**Re: 3800 Texas Drive
New Orleans, LA
Project Number: DR058-25
Our File #: 23-104**

CPC Design Advisory Committee Provisos [10.15.2025] - Response for DR058-25 (3800 Texas Drive)

New Apartments Building

3800 Texas Dr, New Orleans, LA
70114

SHEET TITLE
BUILDING ELEVATIONS

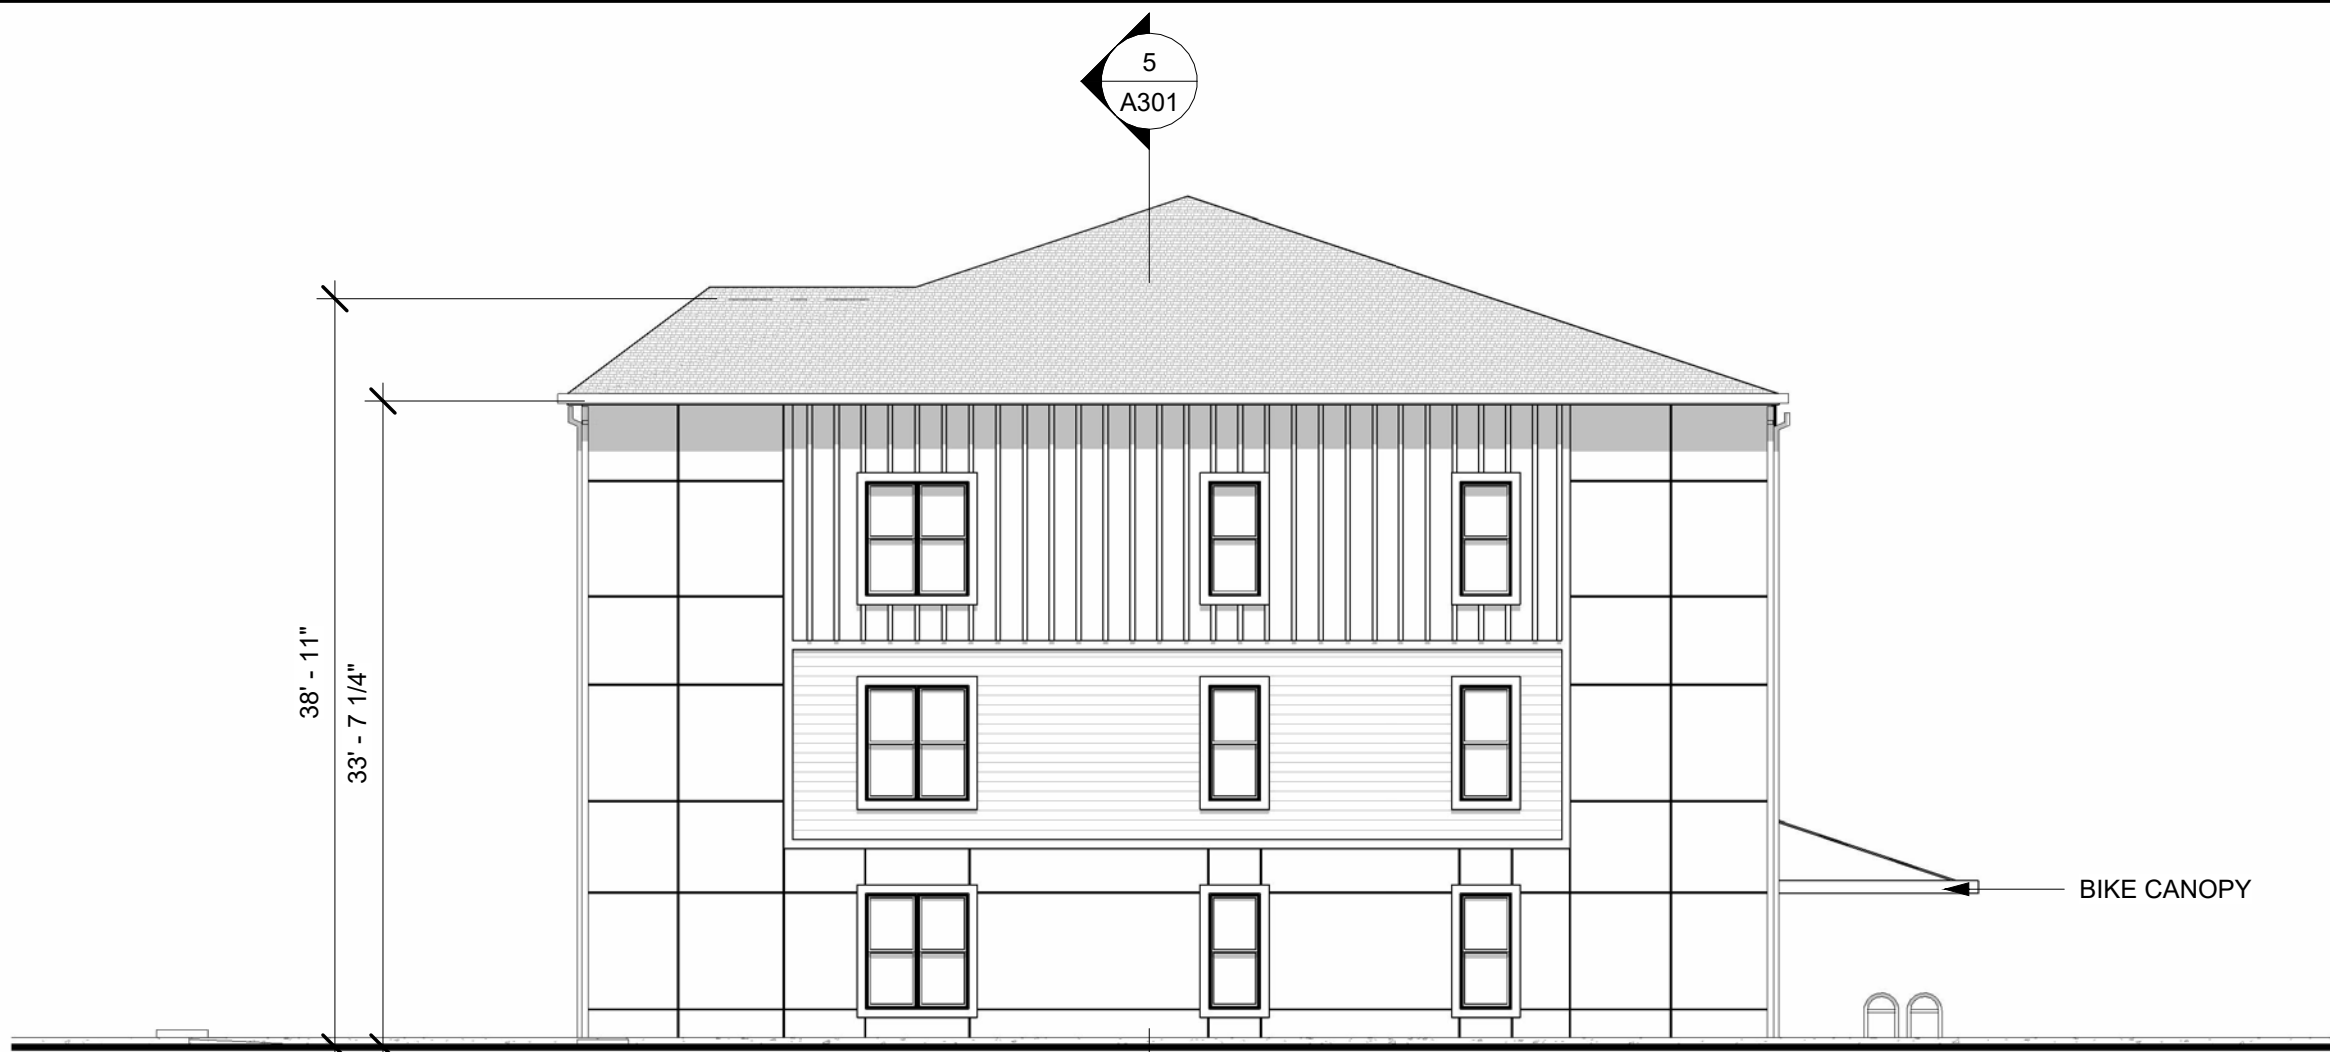
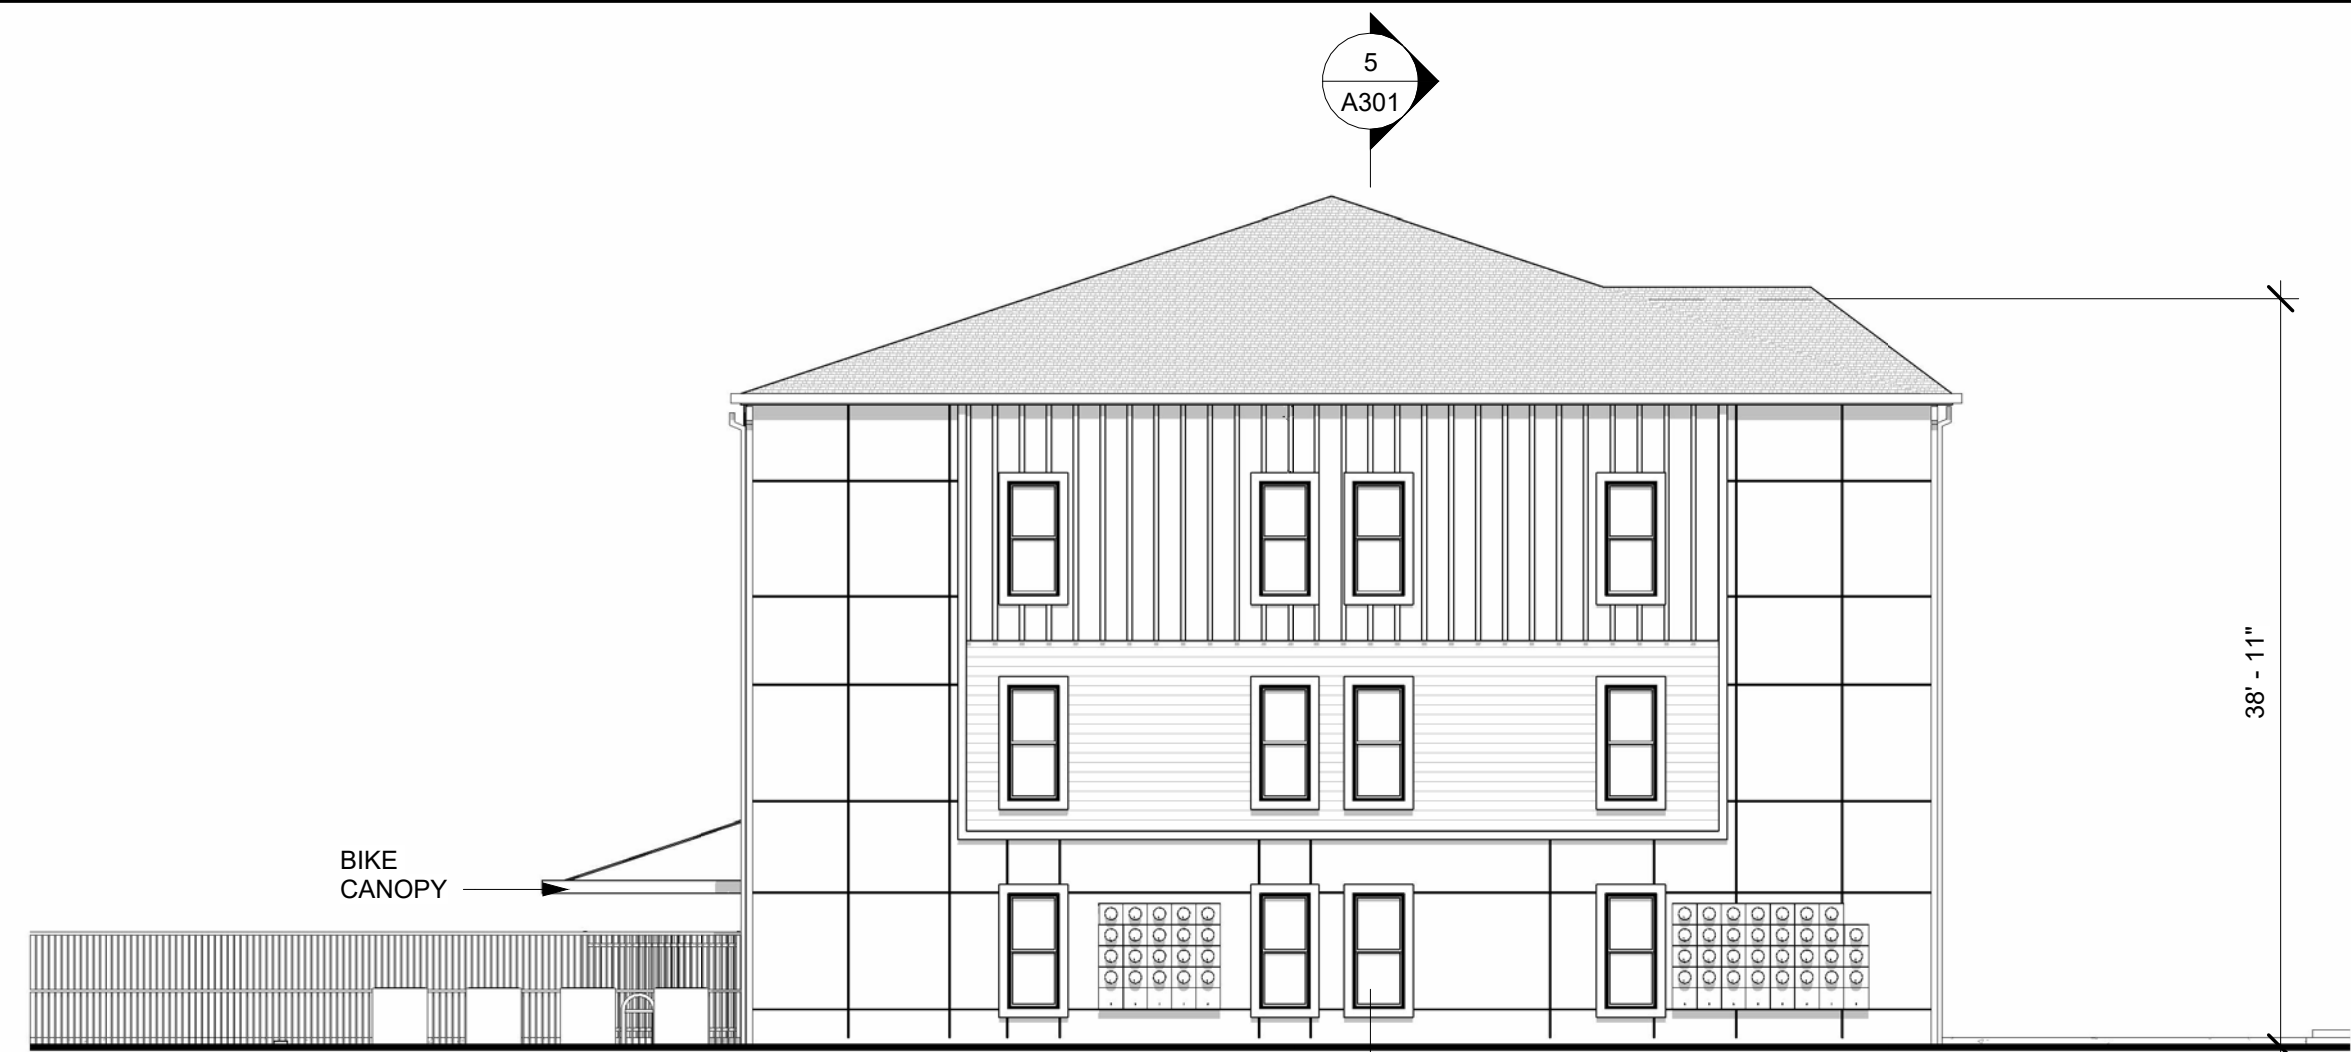
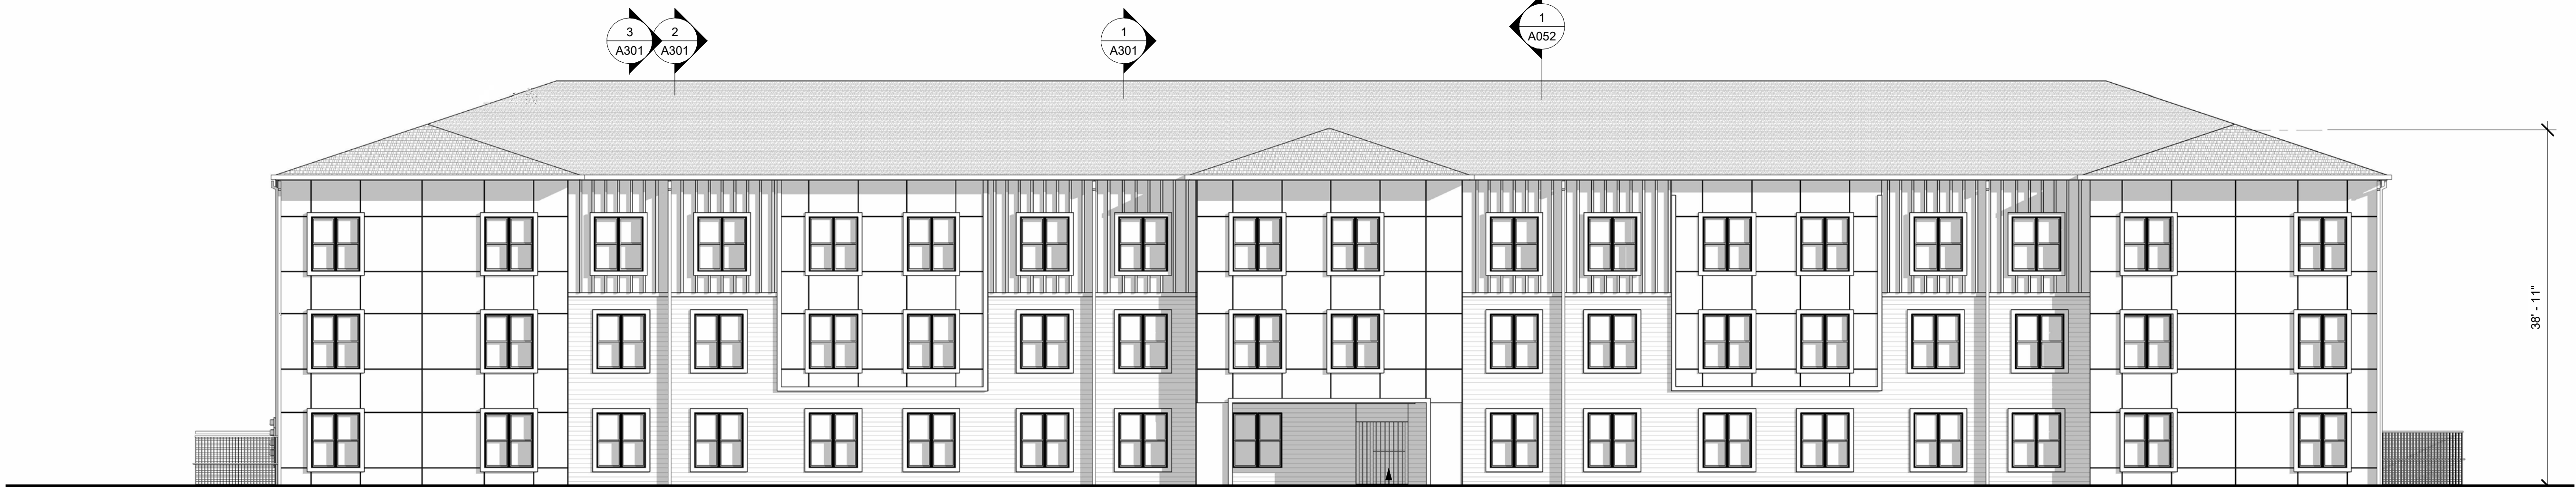
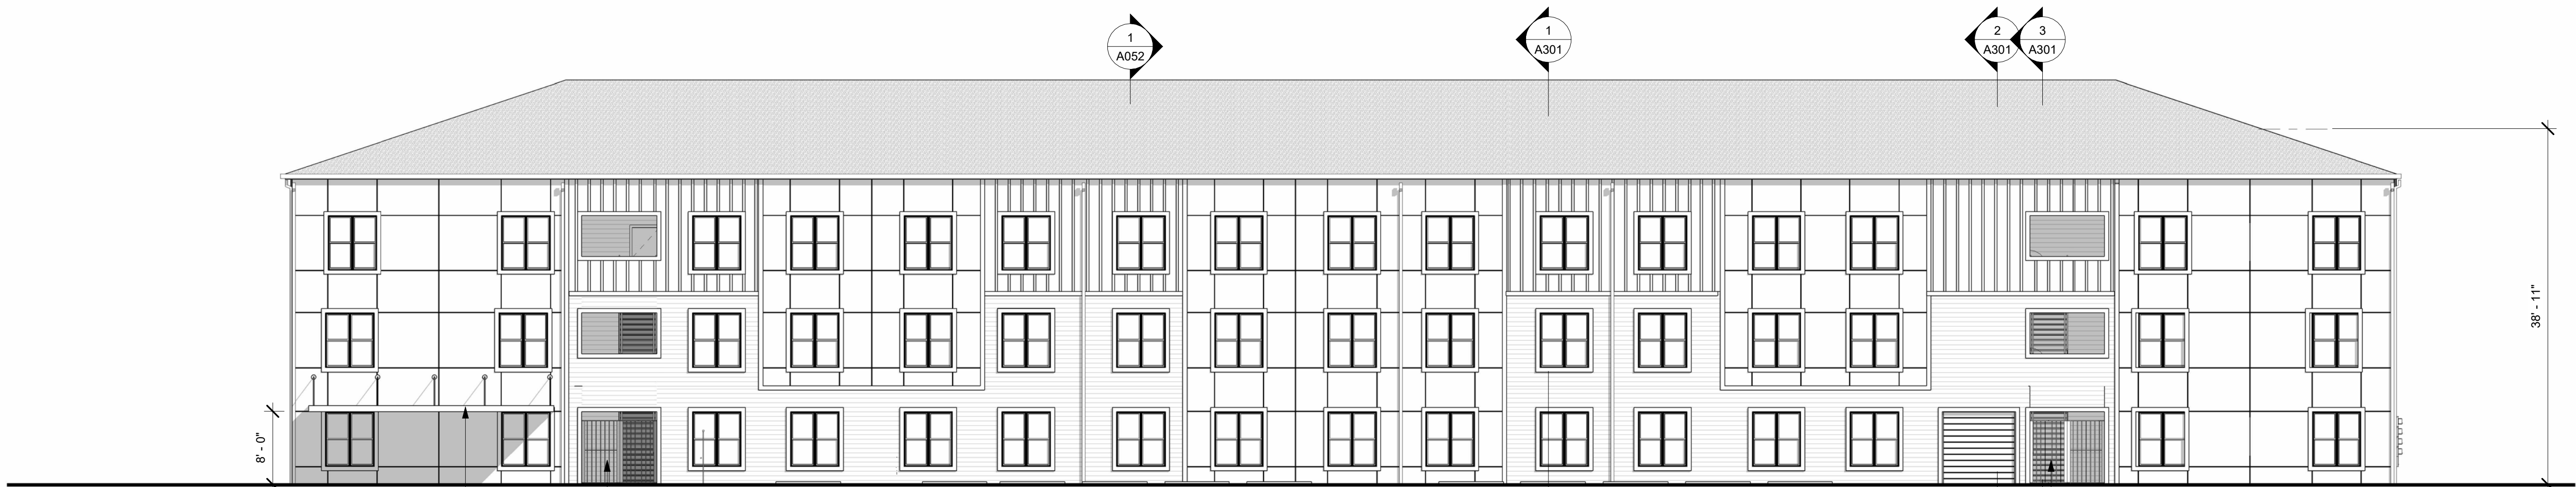
2. Address the monotonous roof line with dormers or gables.

5. Provide visual interest and break down the massing of the front building façade through changes in plane, such as one-foot setbacks for portions, or include material changes to break up the façade.

R:/ The roof line has incorporated hip-end roof geometry, which has been revised to address the monotonous roof line – please see revised A201 – Building Elevation, A202 Building Elevations, and A121 – Roof Plan.

R:/ The massing of the front building façade has been revised with one-foot setbacks and material changes throughout to provide visual interest and break up the façade – please see revised A101 – First Floor Plan and A201 – Building Elevations.
